Subject: Interstate 4 from West of US 27 to the Polk/Osceola County Line Value Engineering Study  
Recommendation Dispositions

FM: 201210-3

Please see below for our management action dispositions for the recommendations found on Table 1.4-1 of the Value Engineering Study Report for I-4 from West of US 27 to the Polk/Osceola County Line.

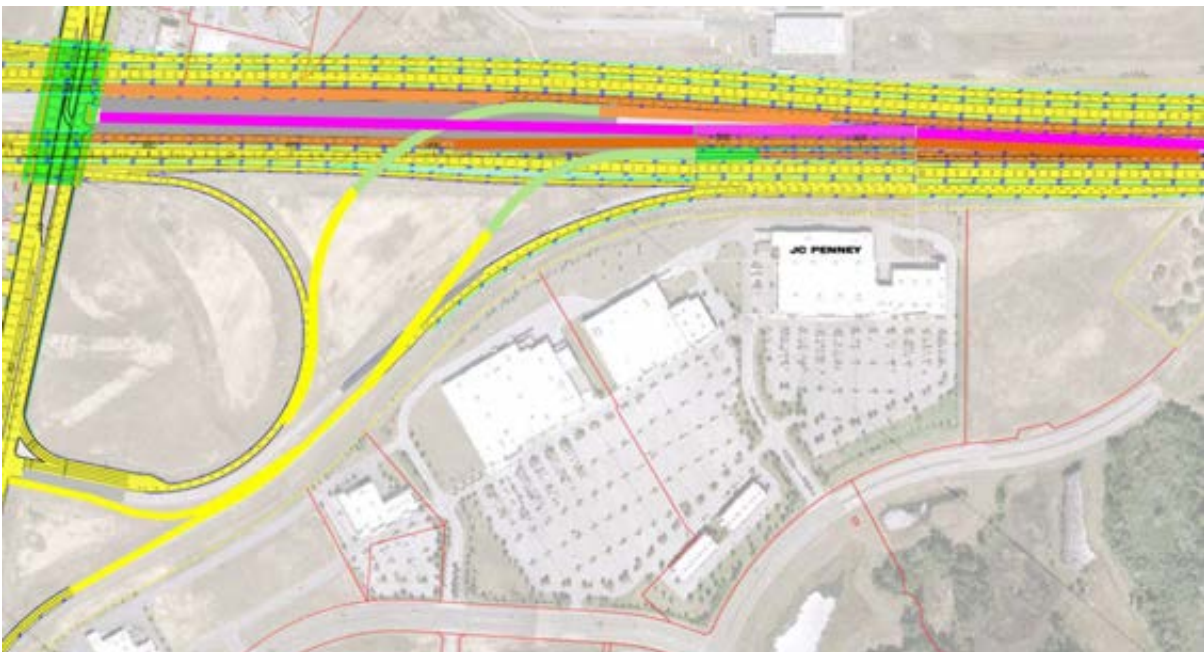
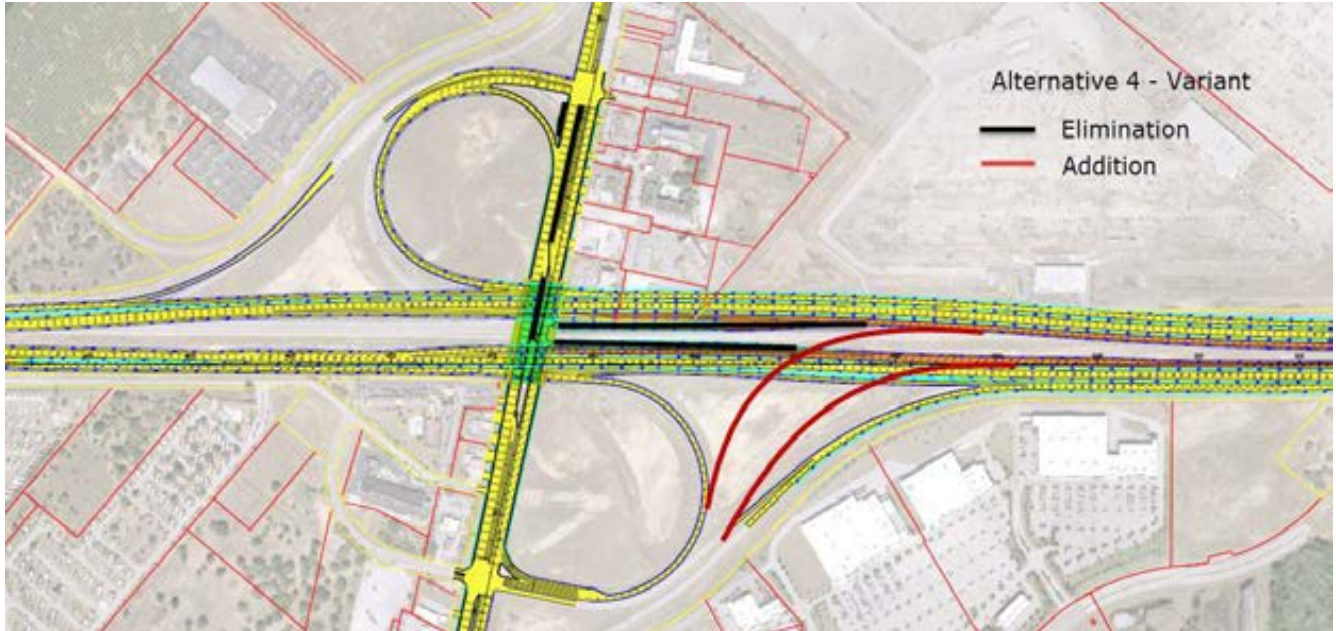
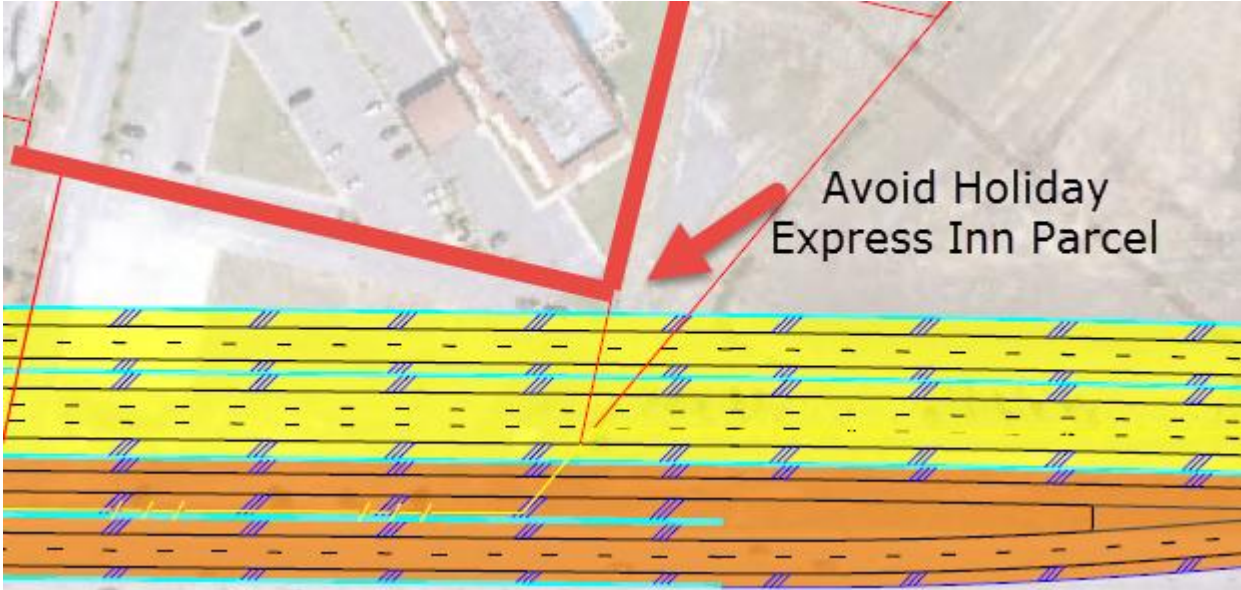
Recommendation BR-07: The alternate would utilize US 27- Alternative 4 that uses signalized intersections at the US 27 ramp tie ins. The difference to Alt. 4 is that the direct connect express lanes are relocated into the existing ramp entrances and entrances at the south intersection, mitigating the original concern with alternative 4 with the ramp tie ins on the bridge.

Eliminate four structures from 'base design'

**Accepted. The express lane tie ins can be moved to the ramps, and the additional intersection previously shown in the middle of US 27 will be eliminated.**

PROJECT:	<b>Florida Department of Transportation</b> <b>I-4 from West of US 27 to Polk/Osceola County Line</b> <b>FPN #201210-3</b>	ALTERNATIVE NO.:  <b>BR-10</b>
DESCRIPTION:	<b>Reconfigure US 27/I-4 Interchange utilizing SPDI and Ramps to CD system</b>	SHEET NO.: <b>1 of 6</b>

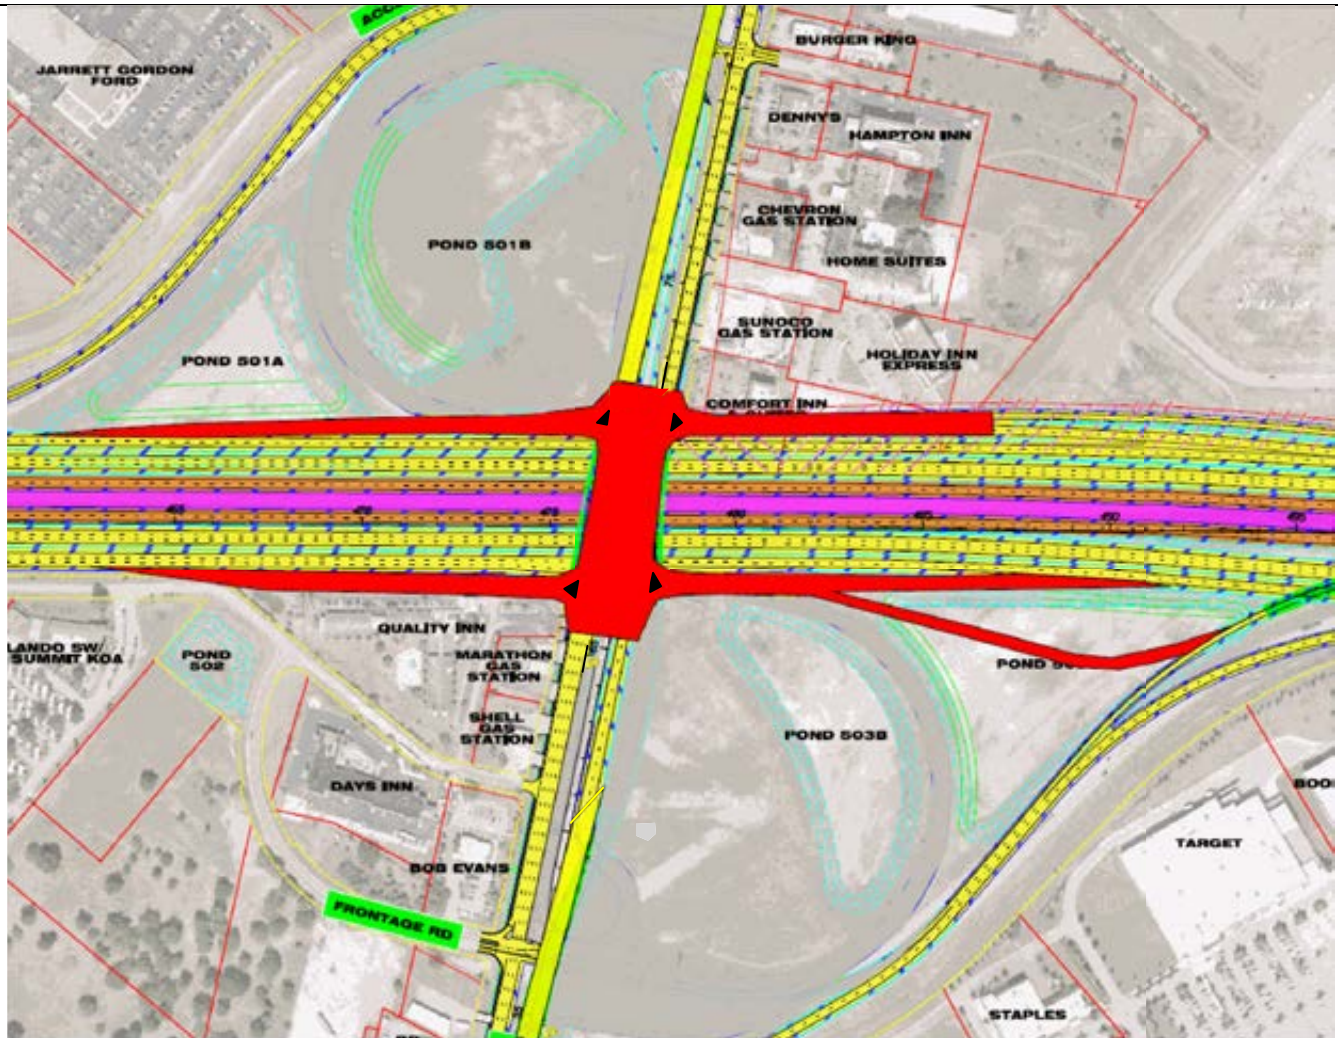
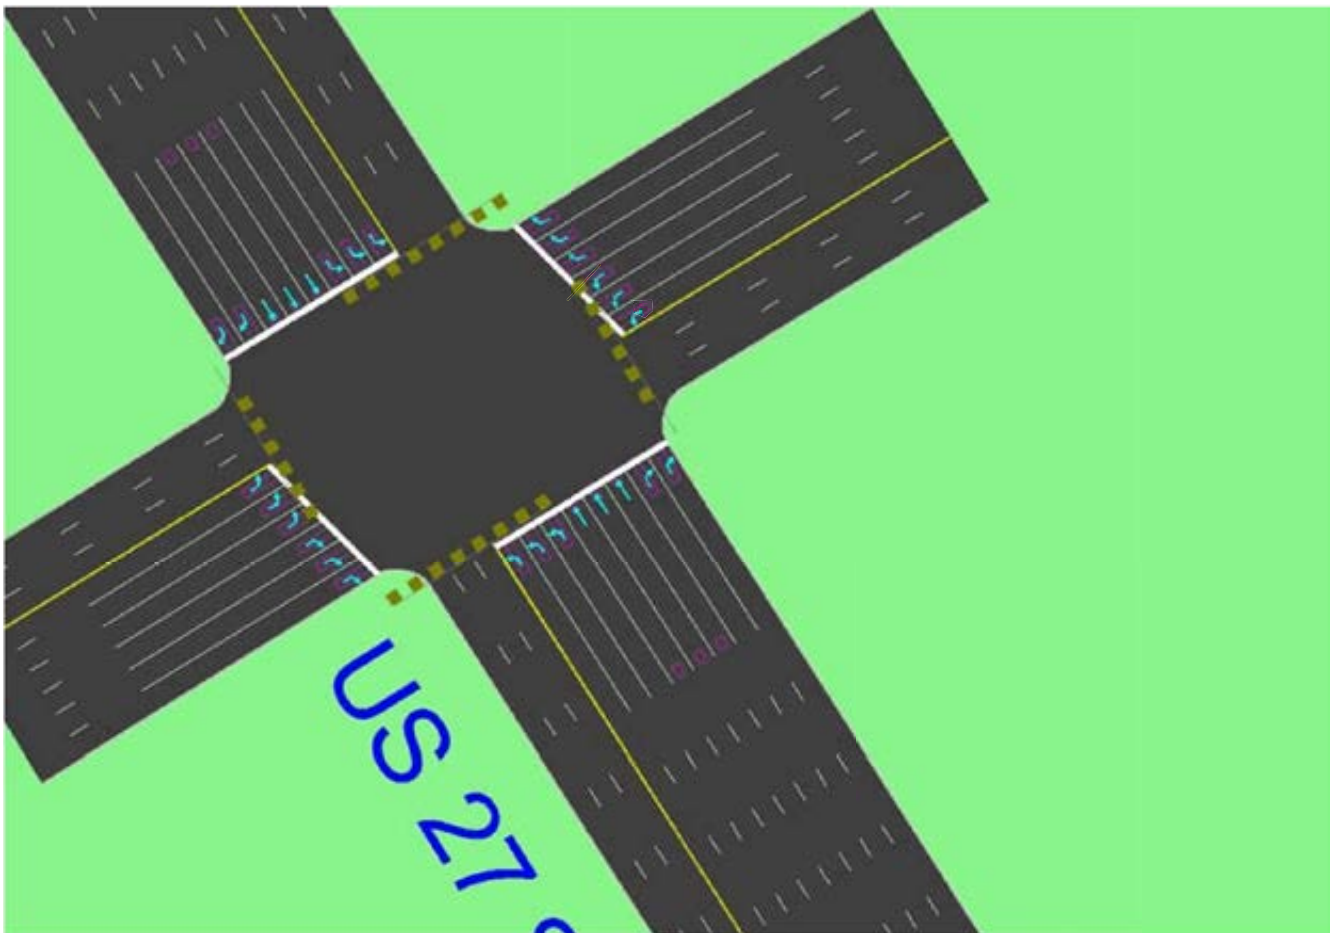
Recommendation BR-10: The alternate proposes a SPDI at the interchange without loops and an option with or without free flow right turn ramps from US 27 to I-4.

This alternative SPDI design eliminates the bridges crossing the two existing signalized intersections on US 27 since the existing ramps/loops are eliminated. This also eliminates the need for large circular U-turn ramps since the two bridges from Alternative 7 are eliminated. With an option to keep the current outside ramps, traffic from US 27 can still access I-4 without stopping at the intersection. Figure 1 on Sheet 3 of 6 illustrates a SPDI intersection at US 27 over I-4. Figure 2 shows the SPDI intersection at SR 436 over I-4 from the I-4 Ultimate project.

The traffic program Synchro was used by the PD&E consultant to analyze the estimated traffic volumes for a No-Build scenario and a SPUI (also known as SPDI) intersection at US 27 and I-4. The SPDI scenario improves operation over a No-Build scenario due to the geometry; however, the SPDI configuration still fails as a result of this analysis. The SPDI intersection was analyzed with all traffic controlled at the SPDI bridge. The results of the analysis and the geometry used are shown on Figure 2 on Sheet 4 of 6. However, by utilizing the existing right turn ramps from US 27 to I-4 the level of service may be improved. Another option would be to build new right turn ramps before the bridge, but closer to the bridge than the current ramps to eliminate wasted space.

**Not Accepted. There are multiple movements that are failing along with v/c ratios over 1.0.**

**RD-7**

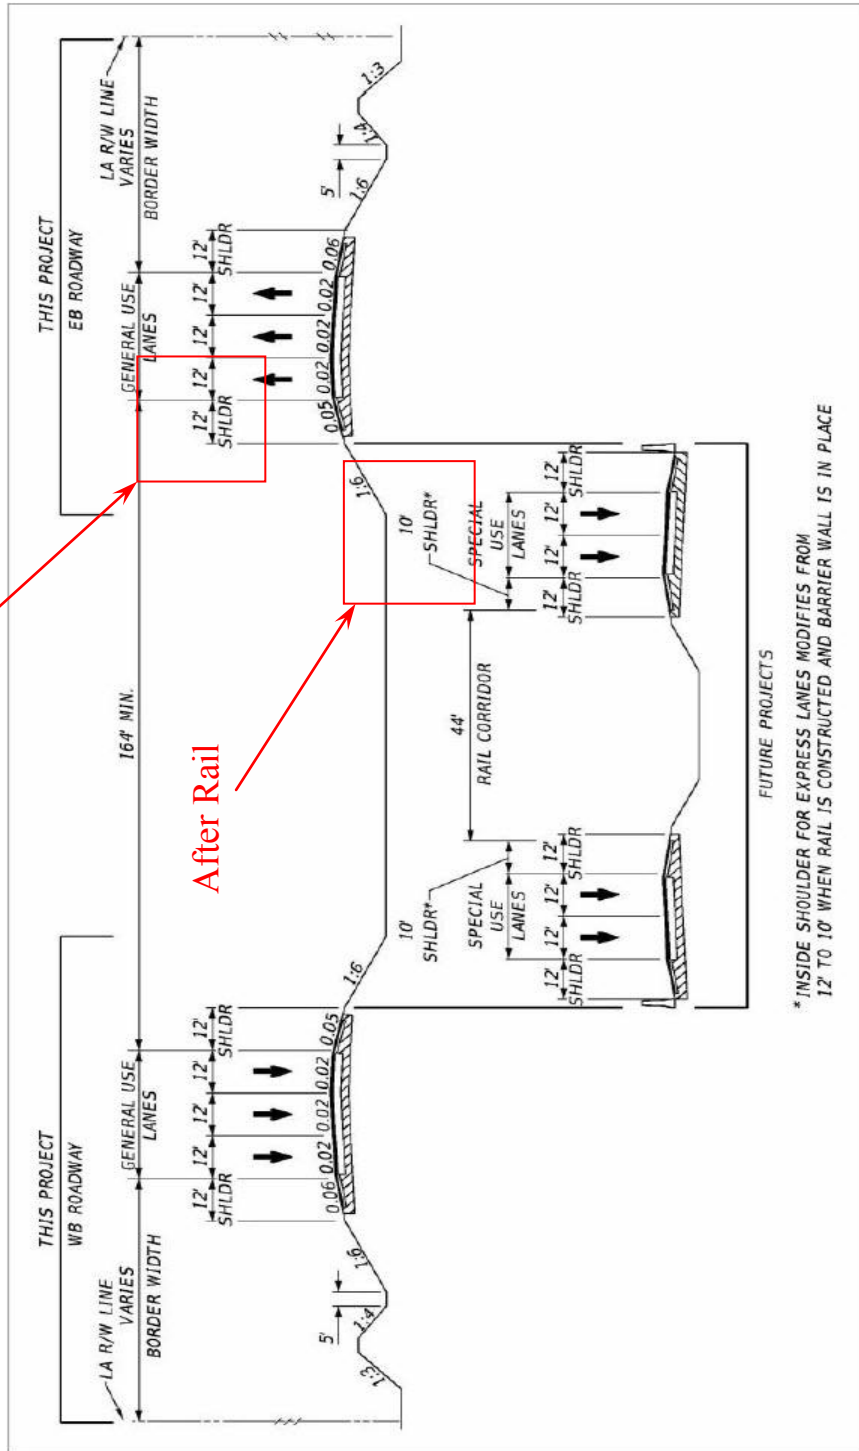
Recommendation RD-07: Provide typical section to match that of District 1 I-4 Master Plan for consistency throughout corridor.

Provide typical section to match that of District 1 I-4 Master Plan for consistency throughout corridor.

The retaining of the 10' inside shoulders for the express lanes will provide conformity to the District 1 I-4 master plan to the west. Yet, this design will not match with District 5's I-4 Ultimate and Beyond plans through metro Orlando into Volusia County.

PROJECT:	<b>Florida Department of Transportation</b> <b>I-4 from West of US 27 to Polk/Osceola County Line</b> <b>FPN #201210-3</b>	ALTERNATIVE NO.: <b>DR-01</b>
DESCRIPTION:	<b>Maximize Existing Ponds within I-4/US 27 Interchange</b>	SHEET NO.: <b>1</b> of <b>2</b>

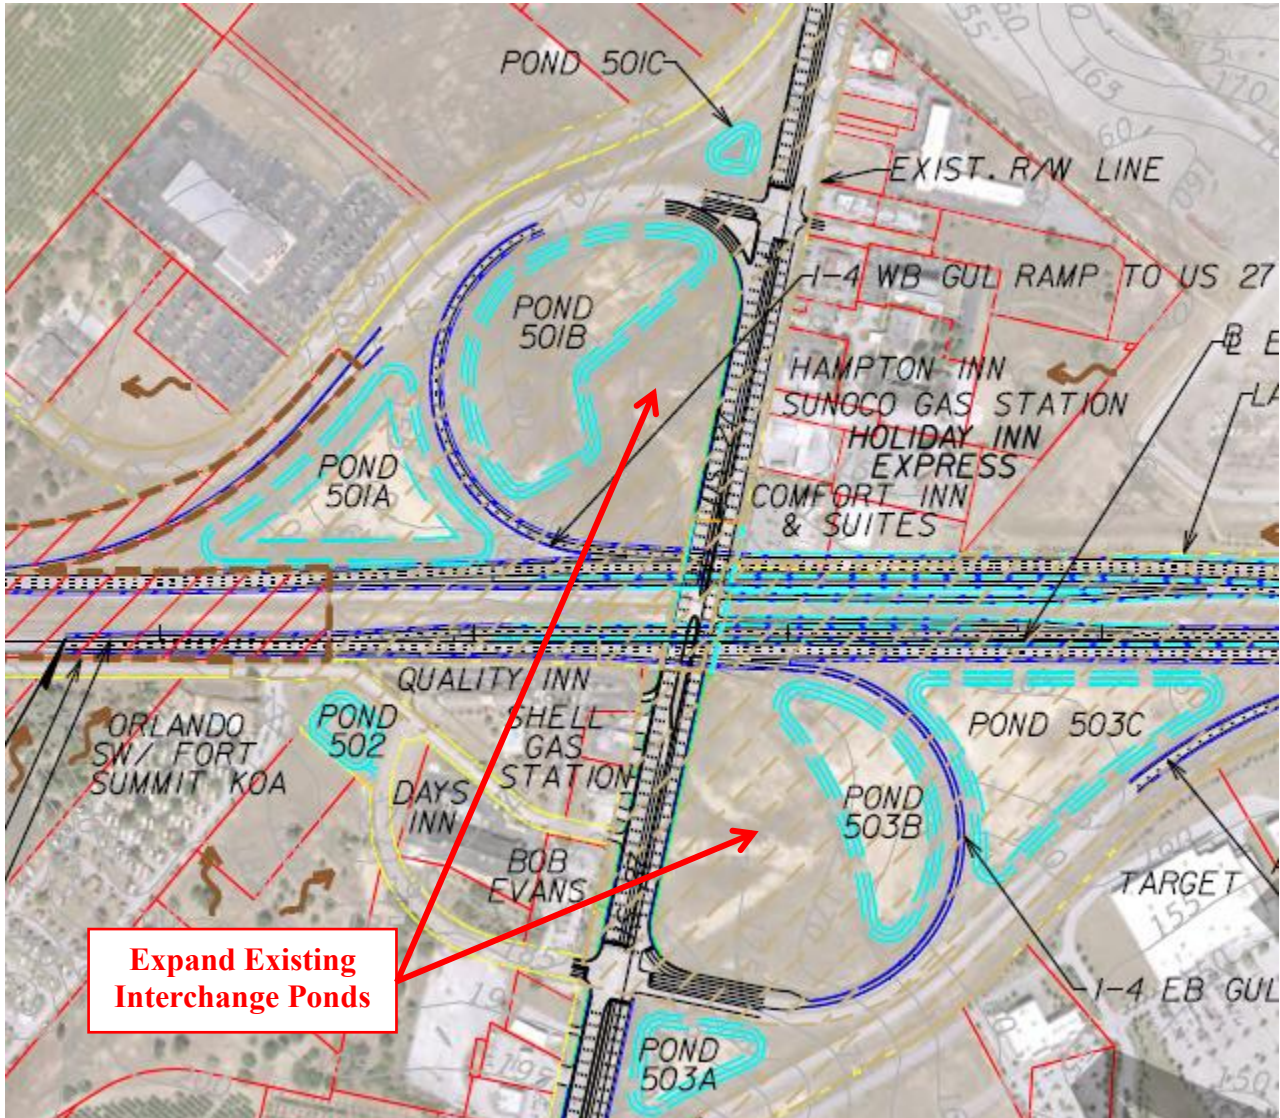
Recommendation DR-01: The alternative suggests maximizing the existing ponds within the I-4/US 27 Interchange for treatment and attenuation. It appears there is more than adequate room within the existing loop ramps, Pond 501B and Pond 503B, to provide additional storage.

The alternative suggests maximizing the existing ponds within the I-4/US 27 Interchange for treatment and attenuation. It appears there is more than adequate room within the existing loop ramps, Pond 501B and Pond 503B, to provide additional storage.

Basin 501 is a closed basin which does not discharge outside of the interchange. Any additional storage provided will help improve water quality, lower design high water levels and limit the risk of flooding within the interchange.

Basin 503 ultimately discharges to the east to the existing floodplain located at 530+00 and ultimately to Horseshoe Creek. The interchange ponds are located in the upstream portion of this basin. In addition to improving water quality, any additional storage will help attenuate runoff discharging to the existing floodplain.
